September 3, 2021

Douglas W. Anderson
Product Manager for Windows, Doors, and Skylights ENERGY STAR® Labeled Products
Anderson.doug@epa.gov
windows@energystar.gov

On behalf of the Fenestration and Glazing Industry Alliance (FGIA), we are asking for reconsideration of the proposed ENERGY STAR 7.0 Draft 1 Residential Windows, Doors and Skylights Specification requirements. FGIA offers alternative recommendations which our members believe are more in line with the spirit of continuous improvement of the program and its acceptance by consumers. FGIA represents more than 350 member companies who manufacture and market windows, doors and skylights and the components that go into them for residential and commercial applications — many of whom are ENERGY STAR partners who label millions of products every year with the ENERGY STAR label.

Table 11. Annual Cost Savings and Payback for the Northern Climate Zone (Proposed Criteria Highlighted)

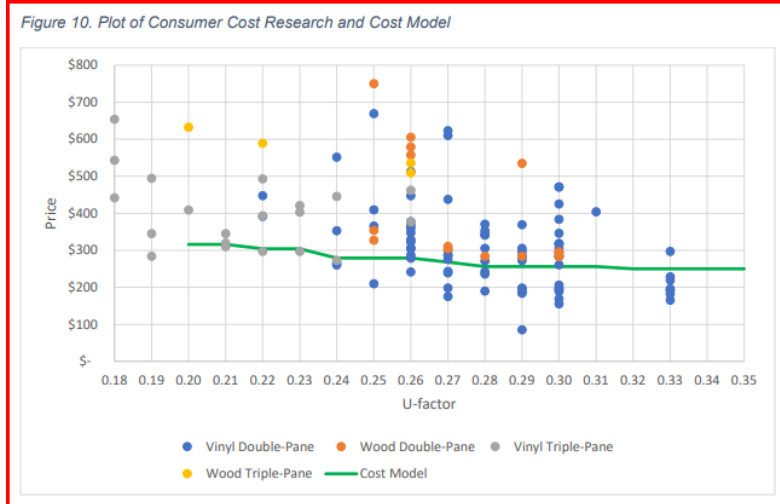
- When comparing ENERGY STAR Version 6 products to Version 7 products, the payback goes out to almost 20 years based on data provided by EPA's analysis report. Table 7 and Table 11 indicate the incremental cost of market baseline, which is higher than EPA's stated under 13-year payback target. It's important to consider the benefit to consumers choosing between Version 6 products versus Version 7. Therefore, it's questionable how consumers would see the benefit and payback going from Version 6 to Version 7, with such a long payback period.

- For example, in Table 11 of the "Criteria Analysis Report by EPA of July 2021," the proposed cost savings for the Northern Zone is misleading in showing an annual cost savings of \$113.99, on a window with a U-factor of 0.22 and a 0.30 SHGC, compared with the current ENERGY STAR U-factor of 0.27, which amounts to only a \$43.13 a year difference. On a monthly basis, that's only a \$3.59 savings for replacing an entire house full of windows

costing thousands of dollars. The consumer would need to invest substantially more to obtain products with 23 percent less U-factor versus the current ENERGY STAR program. We are very concerned that this large 23 percent jump in product performance, for which the consumer only saves \$3.59 a month, will cause a strong, negative reaction by consumers.
